HISTORIC AND DESIGN REVIEW COMMISSION

HDRC CASE NO: 2023-486
ADDRESS: 1100 BROADWAY
LEGAL DESCRIPTION: NCB 463 BLK 43 LOT W 1.6 FT OF S 111.71 FT OF 3,S IRR 111.6 OF 4,S IRR 65 OF 5
ZONING: FBZ T6-1, RIO-2
CITY COUNCIL DIST.: 1
APPLICANT: Gordon von Broock/Professionals Beauty and Image Services LLC (Kiki's)
OWNER: ARCON DEVELOPMENT LTD
TYPE OF WORK: Installation of patio seating within the sidewalk right of way
APPLICATION RECEIVED: December 07, 2023
60-DAY REVIEW: February 5, 2024
CASE MANAGER: Edward Hall

The applicant is requesting a Certificate of Appropriateness for approval to install a patio seating area within the publicly owned right of way at 1100 Broadway. The proposed patio will feature elements on both the Broadway and E Jones sides of the building.

1
A-01 SITE PLAN
SCALE - 4 FEET TO AN INCH
(1/4" = 1' 0")

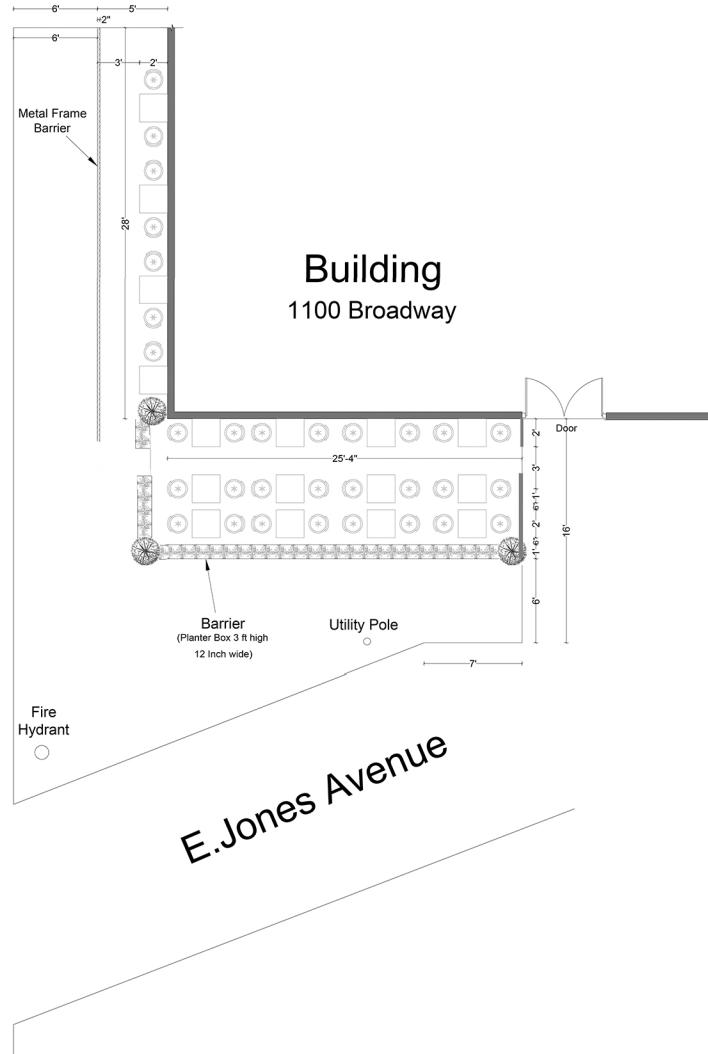
- b. PATIO INSTALLATION (E Jones) – The applicant has proposed to install a raised patio seating area to feature planting boxes to serve as barriers, tables and chairs, artificial turf, ornamental trees and patio umbrellas within the right of way parallel to E Jones. Generally, staff finds the proposed installation to be appropriate. The applicant has noted a clearance of six (6) feet from the proposed installation and the back of the sidewalk curb. Signage and branding should not be installed on any patio elements.

- c. PATIO INSTALLATION (Broadway) – The applicant has proposed to install seating and a railings within the sidewalk right of way parallel to Broadway. Generally, staff finds the proposed installation to be appropriate. The applicant has noted a clearance of six (6) feet from the proposed installation and the back of the sidewalk curb. Signage and branding should not be installed on any patio elements.

- i. That at least six (6) feet of clearance be maintained at all times between the patio furniture/planters and the back of the sidewalk curb.
- ii. That all patio furniture, including tables, chairs, umbrellas and planters are to be submitted to OHP staff for review and approval. All patio furniture should be consistent with the UDC Section 35-674(i)(2). Additionally, all patio elements are to be free of signage and branding.
- iii. That the applicant obtain all required approvals from Center City Development & Operations Department and the Disability Access Office regarding lease agreements and ADA access on site.
